Contract #: 04-0120F4Cty: SF/ALA Rte: 80 PM: 13.2/13.9File #: 69.25B**QUALITY ASSURANCE -- NON-CONFORMANCE REPORT****Location:** Changxing Island, Shanghai, China**Report No:** NCR-000910**Prime Contractor:** American Bridge/Fluor Enterprises, a JV**Date:** 24-Nov-2010**Submitting Contractor:** Zhenhua Port Machinery Company, Ltd (ZPMC), Changxing Island**NCR #:** ZPMC-0872**Type of problem:**

**Reference Description:** New Welding Procedure Not Followed (Rager/McQuaid)**Description of Non-Conformance:**

**Subject:** NCR No. ZPMC-0872

See attached photographs for additional detail.

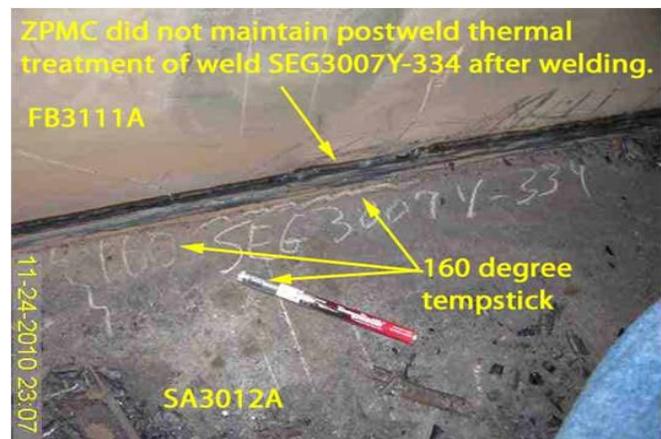
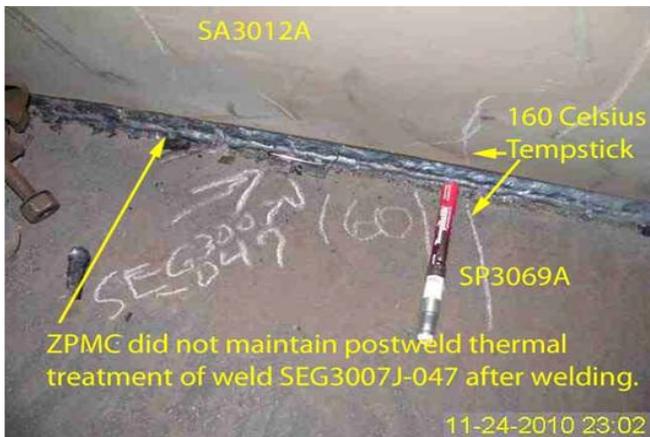
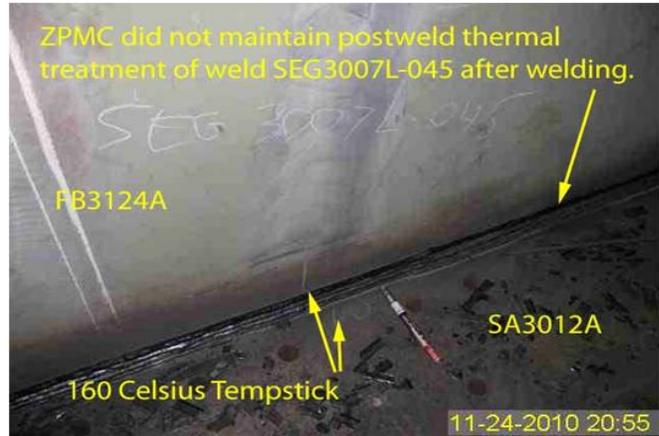
During Caltrans QA in process observations of the fabrication of Orthotropic Box Girder (OBG) 13AE welds SEG3007Y-334, SEG3007J-047, SEG3007L-045, SEG3007L-046 and SEG3007C-175 this QA discovered the following issues: ZPMC welding personnel did not appear to be following the NEW WELD PROCEDURE (Rager/McQuaid)

The following requirements were not followed:

4. Welding (4C)
5. Postweld Thermal Treatment (5A, 5C, 5D)

The weld was identified as SEG3007Y-334

The weld is a complete joint penetration weld that joins Floor Beam FB3111A to Bottom Plate SA3012A. FB3111A and SA3012A are designated on the approved shop drawings as Seismic Performance Critical Members.

The weld was identified as SEG3007C-175

The weld is a complete joint penetration weld that joins Longitudinal Diaphragm LD3026A to Floor Beam FB3120A

Propose a resolution for the identified non-conformance with revised procedures to prevent future occurrences. A response for the resolution of this issue is expected within 7 days.

<b>ZPMC</b> SINOHYDRA PORT MACHINERY CO., LTD.		 CHENWU-TONGSHI JTC 2535
WELDING MAP		
DRAWN	SHOP DRAWING NO.	PAGINATION
CHECKED	SEG3007Y	1/1

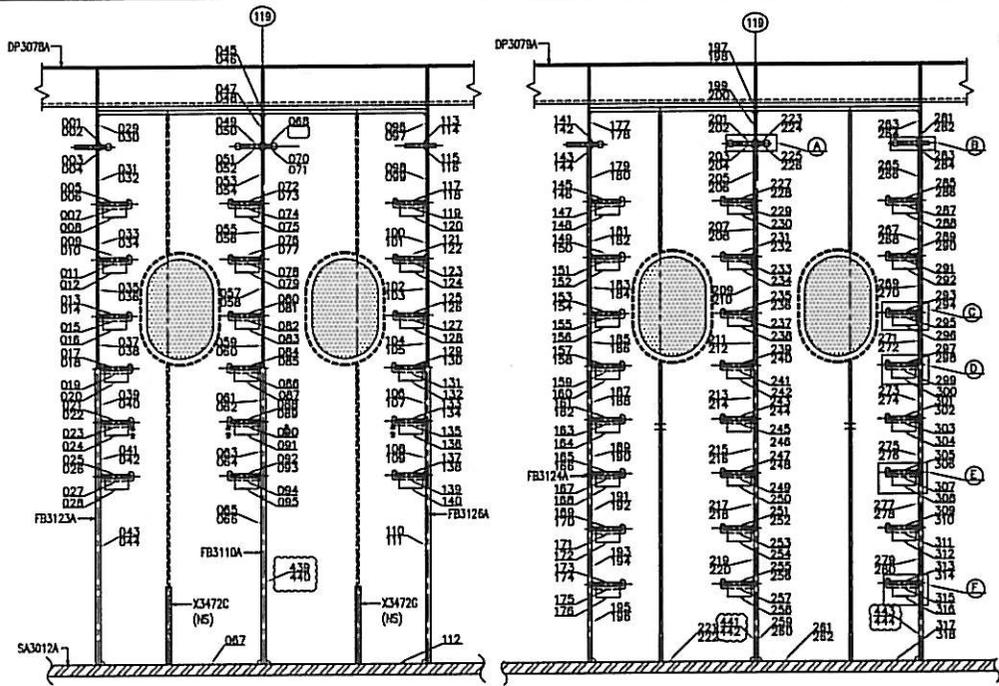
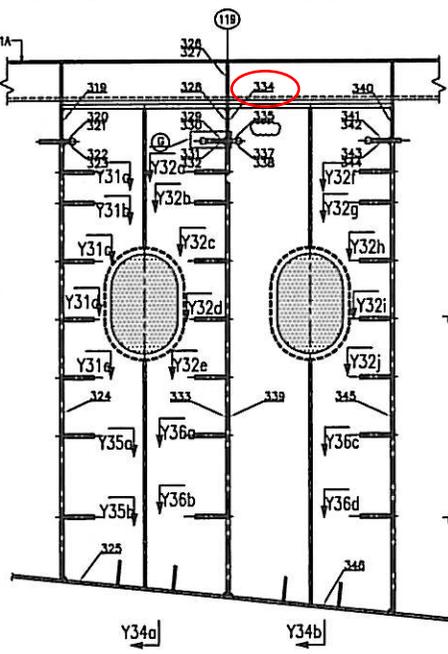
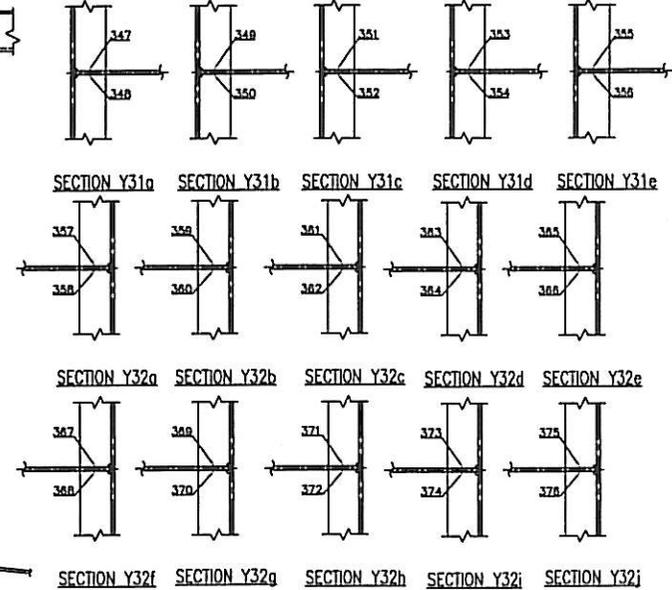
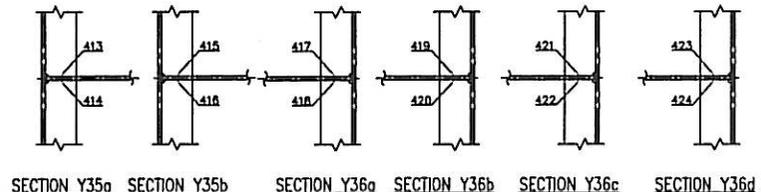
This NPR for NCR ZPMC-0872 is Accepted with Action Pending. The NDT Report for Weld ID SEG3007Y-334 still needs to be submitted.

**Reference Resolution:** The weld identified as SEG3007Y-0334 was welded in the same manner as the other welds noted in this NCR acceptable NDT.

The weld identified as SEG3007Y-0334 was welded in the same manner as the other welds noted in this NCR acceptable NDT of the welds has been provided showing that in this case where the post weld heat treatment was not performed did not adversely affect the weld. Based on this and ZPMC requests closure of this NCR.

This proposed resolution is acceptable. The documentation received is sufficient and the Department concurs that Non-Conformance ZPMC-0872 is closed.
